HISTORIC AND DESIGN REVIEW COMMISSION

November 20, 2024

HDRC CASE NO: 2024-366
ADDRESS: 301 LAVACA ST
LEGAL DESCRIPTION: NCB 708 BLK 8 LOT 1
ZONING: RM-4, H
CITY COUNCIL DIST.: 1
DISTRICT: Lavaca Historic District
APPLICANT: Fernando Morales/Candid Works
OWNER: Kathy Coiner/COINER INVESTMENTS LTD
TYPE OF WORK: Addition, carport, and limestone wall construction; and concrete apron installation
APPLICATION RECEIVED: October 25, 2024
60-DAY REVIEW: December 24, 2024
CASE MANAGER: Bryan Morales

The applicant is requesting a Certificate of Appropriateness for approval to:

4 SITE PLAN AND ROOF PLAN
Scale: 3/32" = 1'-0"

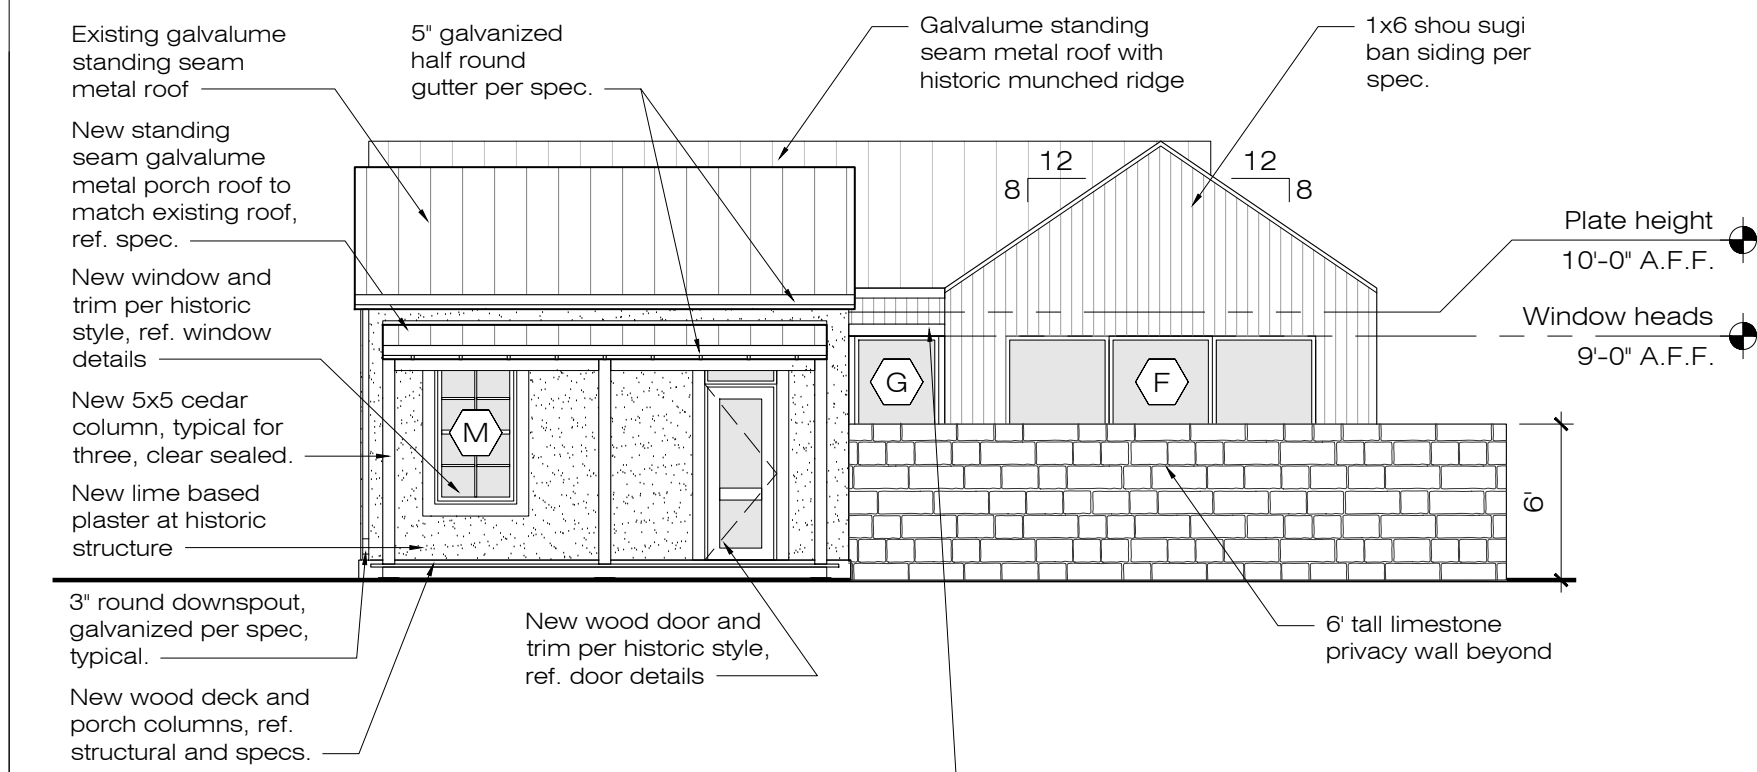
- p. LIMESTONE WALL CONSTRUCTION – The applicant is requesting approval to construct a 6’ tall, limestone privacy wall at the north, south, and west of the property as represented by the submitted site plan. Site Elements 2.B.i. states new fences and walls should appear similar to those used historically within the district in terms of their scale, transparency, and character and the design of the fence should respond to the design and materials of the house or main structure. Site Elements 2.B.v. states to construct new fences or walls of materials similar to fence materials historically used in the district and to select materials that are similar in scale, texture, color, and form as those historically used in the district, and that are compatible with the main structure. Staff finds the limestone wall construction at the north and west conforms to guidelines; however, the color of the limestone wall should conform to existing stone elements within the Lavaca Historic District. Staff finds the limestone wall construction at the south generally appropriate; however, the location of the wall should be set further back from the historic structure’s front wall plane.

Item 4: Staff recommends approval of the 6’ tall, limestone privacy wall, based on finding p, with the following stipulations:

- i. That the applicant provide staff an example of the limestone prior to installation for final approval.
- ii. That the applicant relocated the southern-most limestone wall further back from the historic structure’s front wall plane to be flush with the addition’s southern-most wall plane.
